Access Compliance Report

Public Rights-of-Way

(Curb Ramps)

Intersection ID: 53281	Main Street: BENFIELD_RD	Cross Street: CRAVEN_THOMAS_RD	Location:	N
ADA ID: 33554F79D606	Ramp Type: Perp	Initial Pass/Fail: Fail	Overall Compliance: No	Severity Score: 8.75

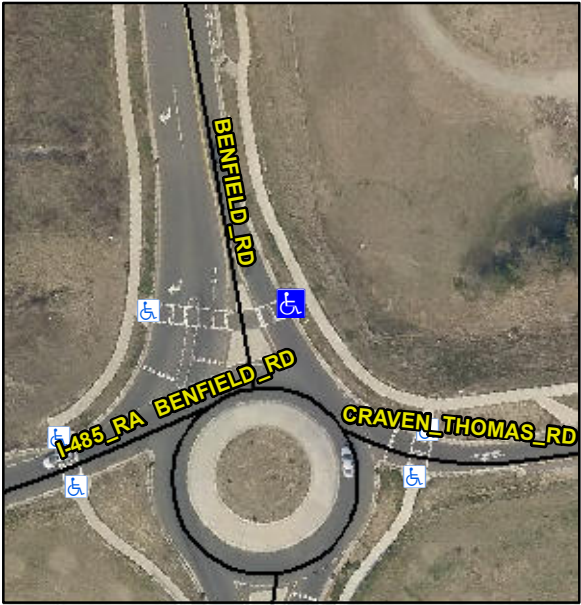
Codes/Mitigation Info/Possible Solution			Field Measurements/Component Compliance		
	Possible Solutions:		Compliance	Description	Data
	Remove & Replace Entire Ramp.		N/A	Ramp Length (in)	89.5
			No	Ramp Width (in)	47.5
			N/A	Flare Type LT	N/A
			N/A	Flare Slope LT (%)	N/A
			N/A	Flare Traversable LT?	N/A
			N/A	Landing Length (in)	N/A
			N/A	Landing Width (in)	N/A
			N/A	Landing Slope (%)	N/A
			N/A	Landing X Slope (%)	N/A
<p>Surveyor Notes:</p> <p>N/A</p> <p>PROW/ADA:</p> <p>R304.5.1</p>			N/A	Flare Type RT	N/A
			N/A	Flare Slope RT (%)	N/A
			N/A	Flare Traversable RT?	N/A
			N/A	DWS Provided?	N/A
			N/A	DWS Contrast?	N/A
			N/A	DWS Length (in)	N/A
			N/A	DWS Full Width?	N/A
			N/A	DWS Offset (in)	N/A
			N/A	Gutter Slope (%)	N/A
			N/A	Gutter X Slope (%)	N/A
<p>Total Cost:</p> <p>\$ 1850.00</p>			N/A	Painted X Walk1?	N/A
			N/A	Painted X Walk2?	N/A
			N/A	X Walk 1 Direction	To W
			N/A	X Walk 2 Direction	N/A
			N/A	X Walk 1 Width (in)	104.5

N/A	X Walk 2 Width (in)	N/A
			N/A	X Walk 1 Slope (%)	0.7
			N/A	X Walk 2 Slope (%)	N/A
			N/A	X Walk 1 X Slope (%)	1.5
			N/A	X Walk 2 X Slope (%)	N/A
			N/A	Ramp inside XWalk1?	Yes
			N/A	Ramp inside XWalk2?	N/A
			N/A	Clear Space?	N/A
			N/A	Clear Space to XWalk (in)	N/A
			N/A	Storm Grate/Utility Hazard?	N/A
			N/A	Storm Grate/Utility Type	N/A
			N/A	Surface Condition? (G/P)	Good
			N/A		
			N/A		
			N/A
